**Former Chatsworth Mill, Williams Road, Gorton,
Manchester, M18 7AY.**

**Information for the discharge of drainage related planning condition for
Application No: 129852/FO/2021.**

Title
Flow Control Detail

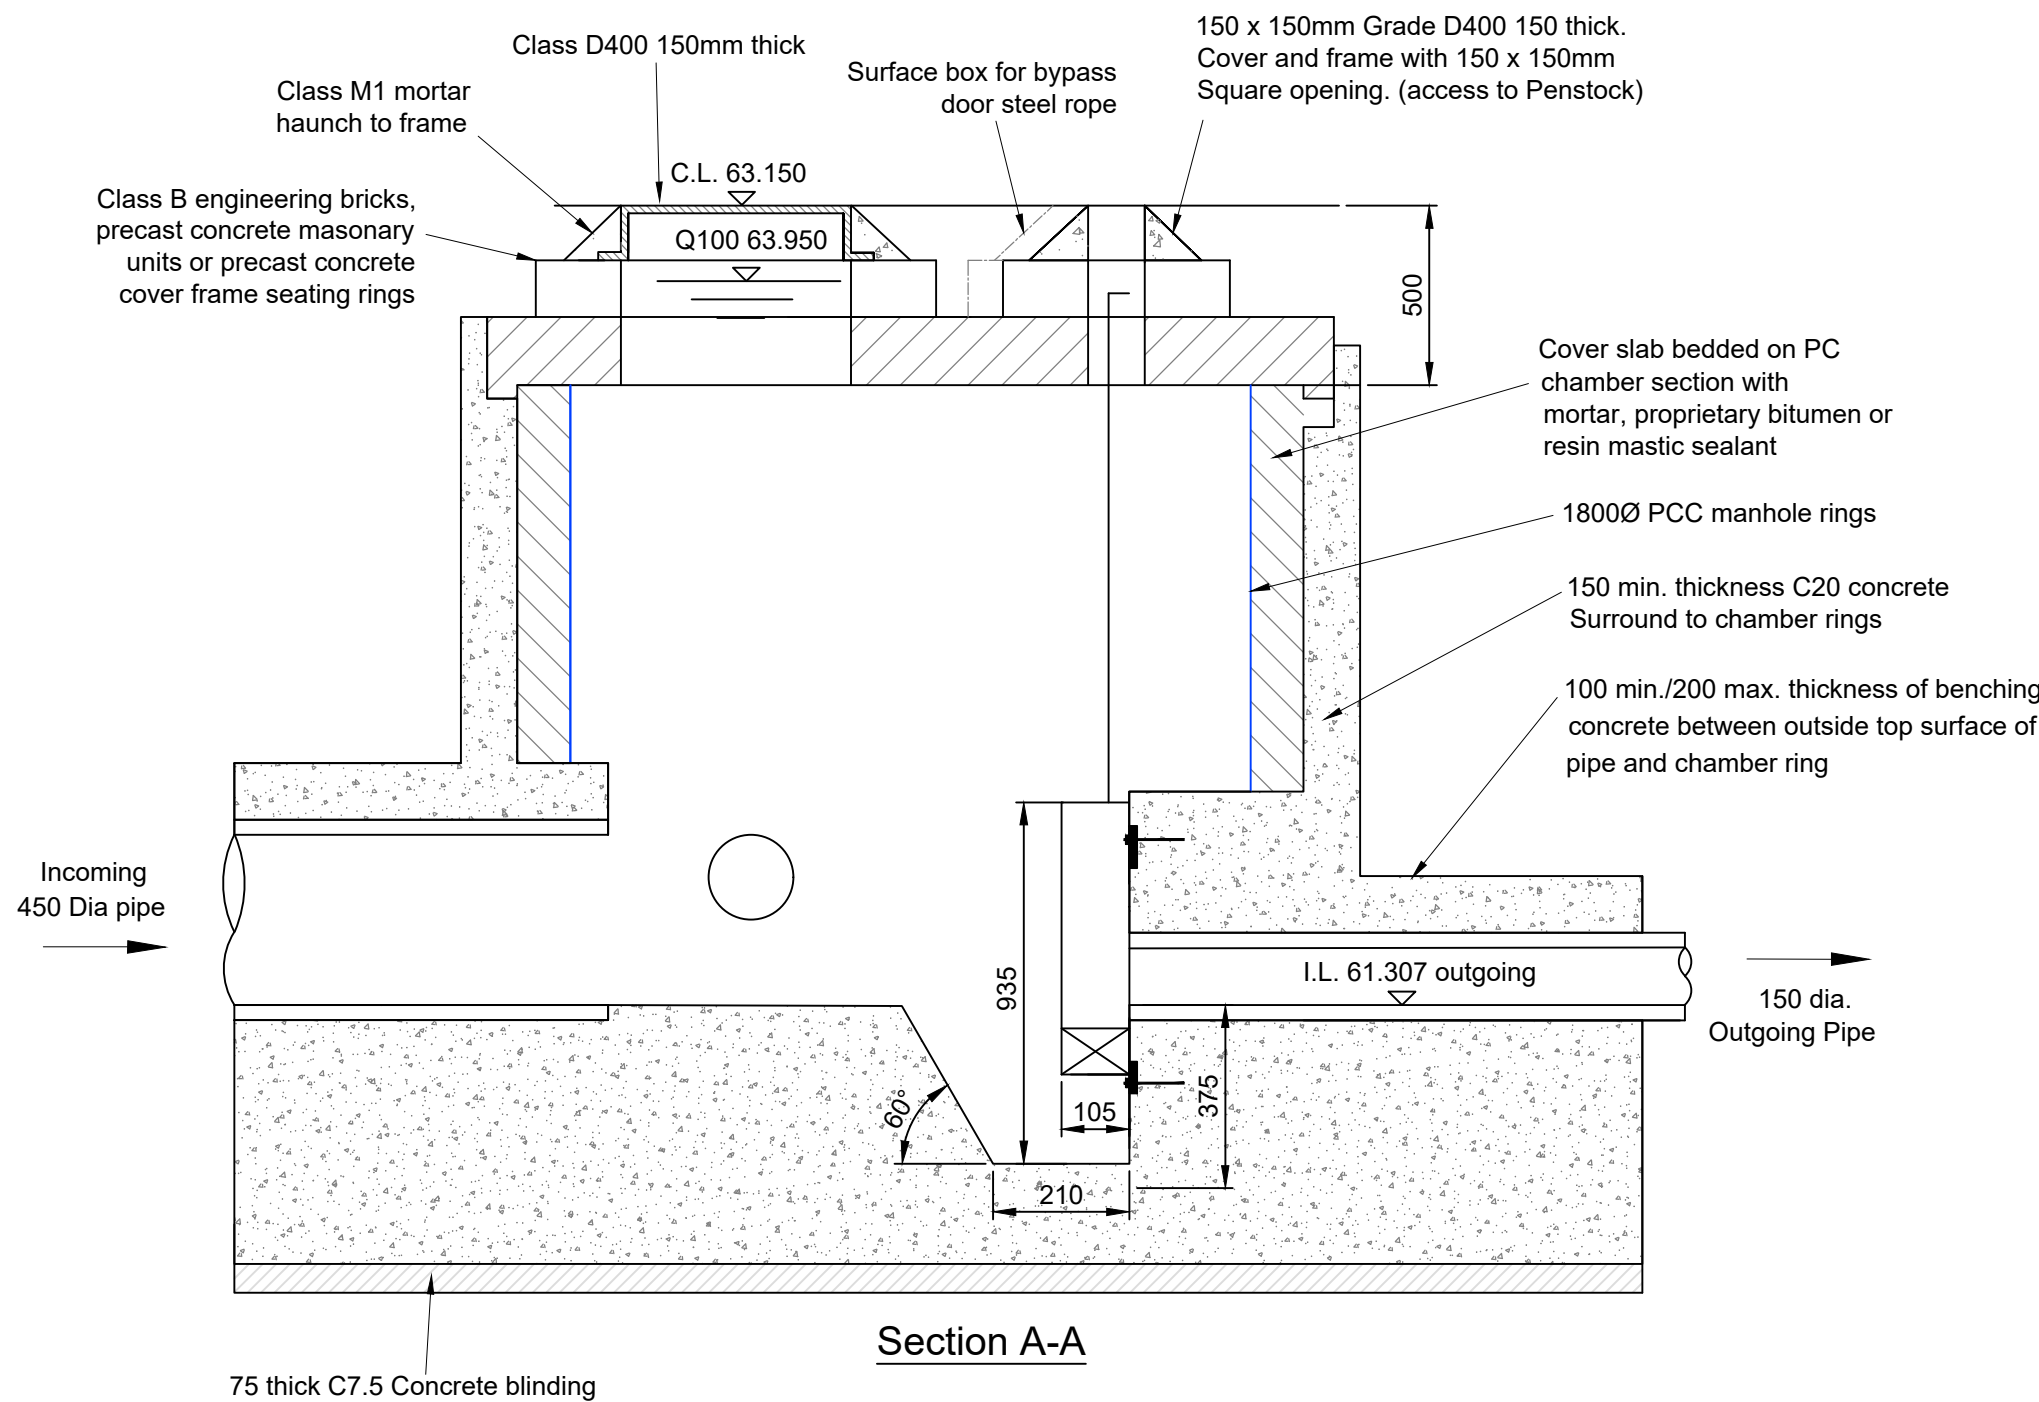
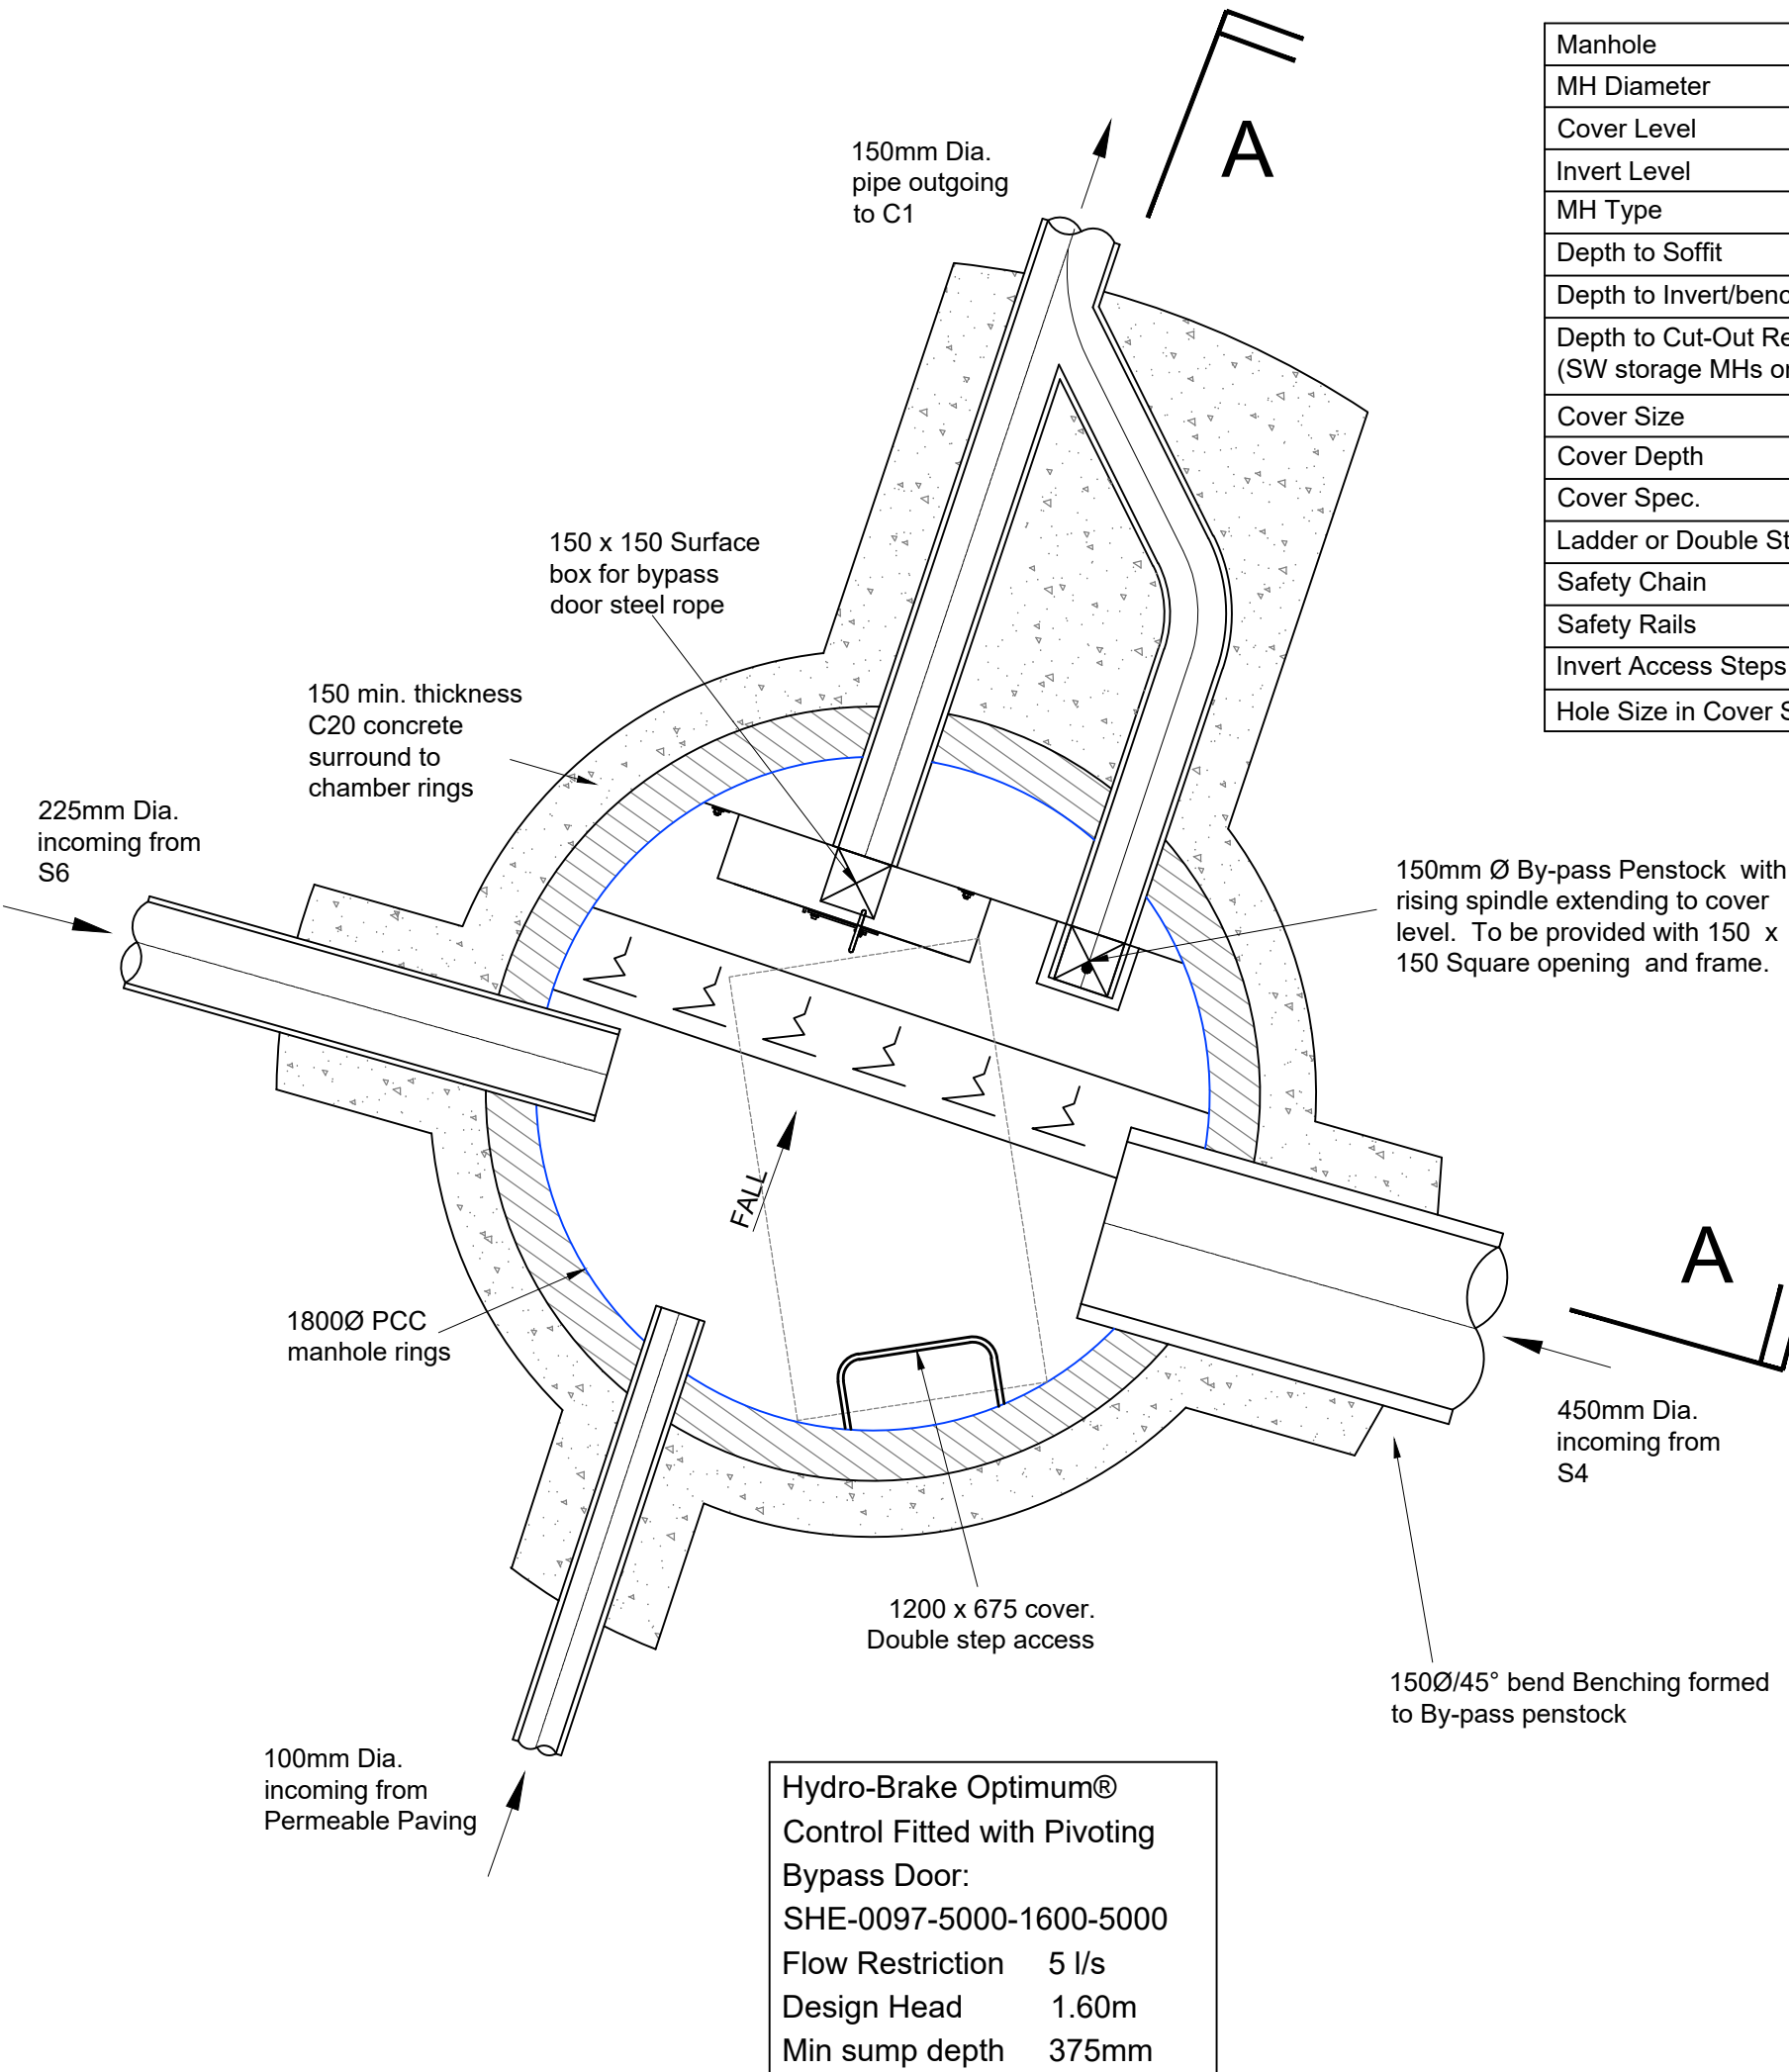
- Construction details of flow control and SuDS elements.

Please see Coopers Drg 7588 / PL01_A Drainage Strategy, Drg 7588 / 11 Flow Control Details & Drg 7588 / 12 SUDs details in Appendix 4
